Storyteller Overland, LLC Customer Service Department 428 Industrial Lane Birmingham, AL 35211

SUBJECT: NHTSA Recall: 22V-770

NHTSA Recall # 22V-770 Inspection & Repair Instructions

Rev10282022

Figure 2

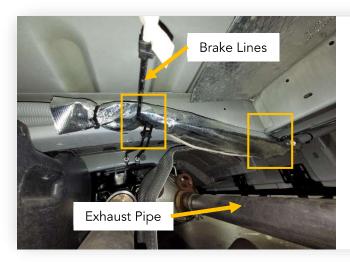
- 2. Access underneath the rear of the van from the passenger side just in front of the rear wheel. NOTE: It is highly encouraged to use a lift for easy access underneath the van.
- 3. Locate the 2/0 awg cables wrapped in heat sleeving that are routed across the van floor from the passenger's side to the driver's side above the exhaust pipes, brake lines, driveshaft, etc. Verify the cables are <u>not</u> supported above the brake lines and exhaust pipes in the two locations as shown in figure 1 below. If they are <u>not</u> supported (such as the cables in figure 2), repair per the procedures in steps 14-16, then proceed to step 4 to continue inspection. If they are supported, continue to step 4.

Cables hanging unsupported on the brake lines and above exhaust pipes

Figure 11
Secure cables above brake lines with a heavy-duty cable tie.

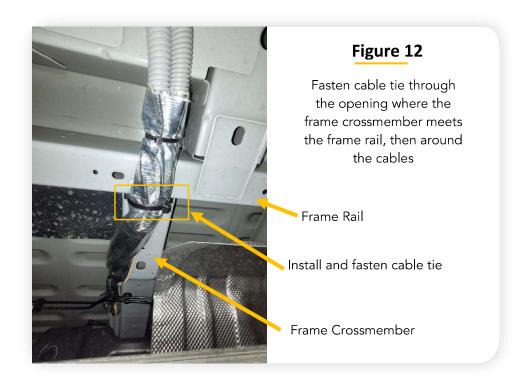
14. Using one of the supplied heavy-duty cable ties, secure the heat sleeved cables above the brake lines by routing the cable tie through the small hole and out the large hole in the frame crossmember just above the brake lines. Fasten the cable tie around the cables, pull tight, and clip the excess cable tie end off with flush cutters. See figure 11.

Should look like this after step 14

Figure 13

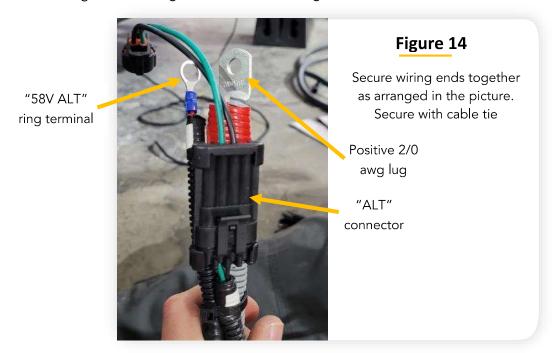
16. The cables should now be secured above the brake lines and exhaust components as shown in figure 13.

Harness now secured above brake lines and exhaust components 17. Hold the ends of the "58V ALT" harness and the positive 2/0 awg together so the ring terminal/lug can be overlapped. Then hold the "ALT" harness branch connector about 1" back from the cable lug. Secure wiring with a cable tie. See figure 14.

Figure 17

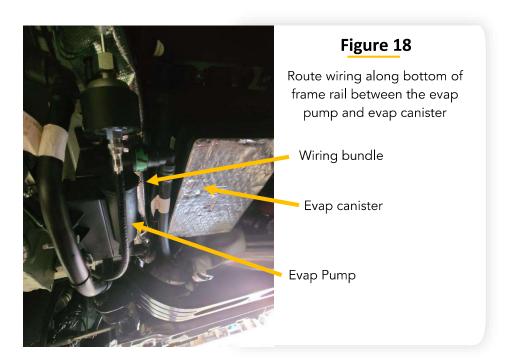
Slide heat sleeving over end of wiring so 2 ft of wiring sticks out 20. Cut and install an 18" section of heat sleeving over the ground cable and the positive cable bundle so the sleeving stops just before the cable lugs. Secure the sleeving to the cables with cable ties. Then slide the end of the 66" section of heat sleeving just past the end of the two 18" sections and secure both ends of the 66" section with a cable tie. See figure 17.

Slide 18" sections of heat sleeving over ends of wiring and secure with cable ties.
Then overlap the end of the 66" heat sleeve section on top and secure with cable tie

Figure 19

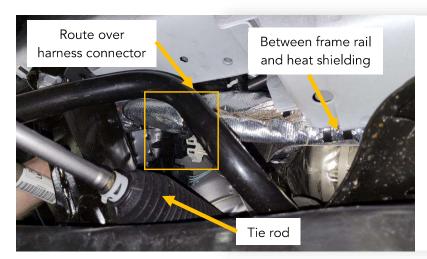
22. Continue routing the wiring forward between the frame rail and exhaust heat shielding toward the front CV axle shaft. Make sure the bundle goes above the factory harness connector mounted just above the tie rod. See figure 19

Route wiring between frame rail and heat shielding, then above harness connector that is above the tie rod

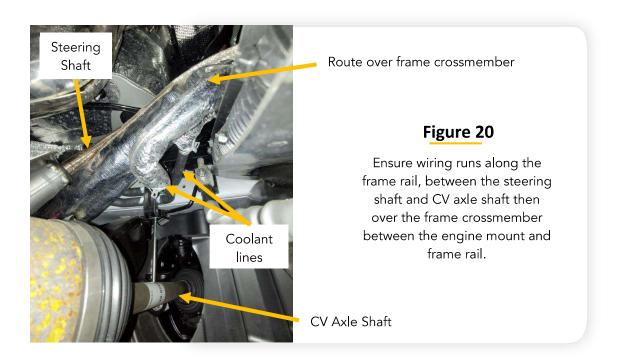
23. When at the front CV axle shaft, run the wire bundle under the steering shaft then over the two factory coolant lines. Route the wiring between the frame rail and driver's side engine mount on top of the frame crossmember. See figure 20
